FINAL PLAT OF
**"DOVE HAVEN
 SECOND ADDITION"**
 SEDGWICK COUNTY, KANSAS
 IN THE SOUTHWEST QUARTER OF SECTION 35,
 TOWNSHIP 28 SOUTH, RANGE 2 WEST OF THE 6TH P.M.

RE: SUB 2002-47 -- Final Plat of Dove Haven Second Addition

At the regular meeting of the Subdivision Committee of the Metropolitan Area Planning Commission on Thursday, July 18, 2002, the above captioned plat was considered. The action of the Committee was to approve the one-step final plat, subject to the following:

CASE NUMBER: SUB 2002-47 -- DOVE HAVEN SECOND ADDITION

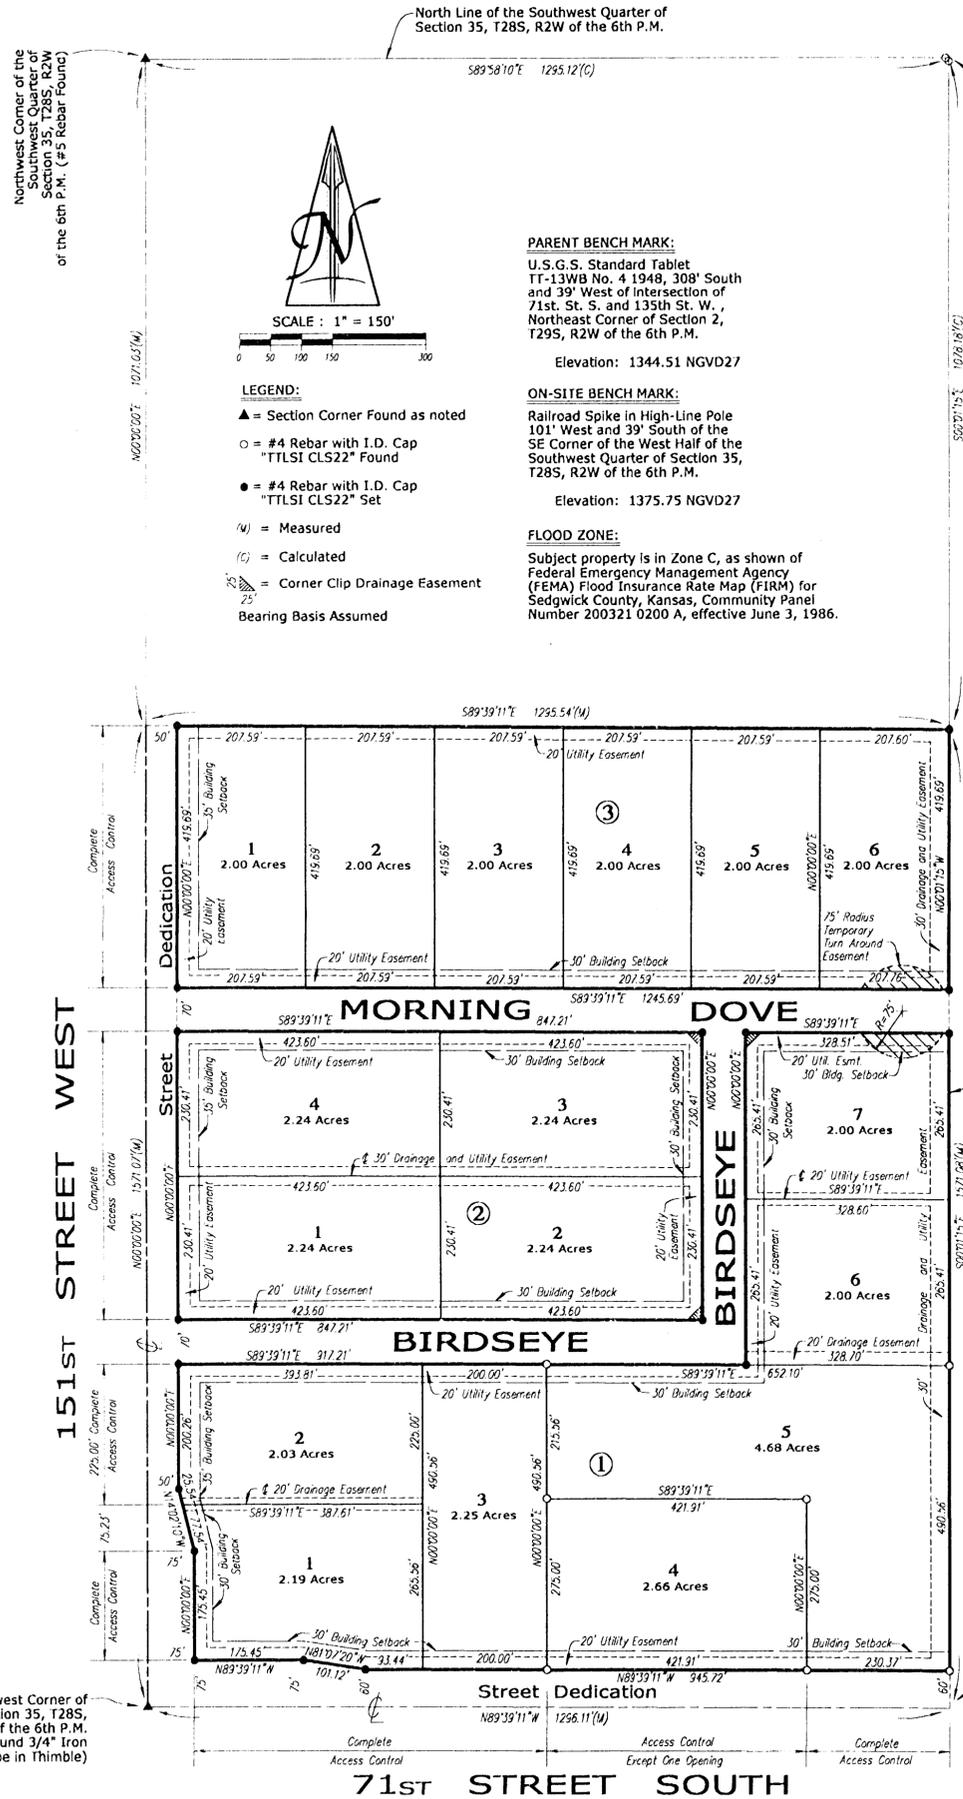
- D. **County Engineering** needs to comment on the status of the applicant's drainage plan. *A final drainage plan is needed. Additional easements/floodways may be needed based on final drainage plans. The drainage plan should indicate removal of terraces.*

- E. **County Engineering** needs to comment on the access controls. The plat proposes one access opening along 151st St. West and one opening along 71st Street South. Distances should be shown for all segments of access control. The final plat shall reference the dedication of access controls in the plat's text. *County Engineering has required complete access control off 71st St. South, for Lot 5, Block 1 and for Lot 1, Block 1.*

- K. The **County Fire Department/GIS** needs to comment on the plat's street names. **Winesap shall be revised to Morning Dove. Bird's Eye shall be revised to Birdseye.**

Access controls have been platted as requested.
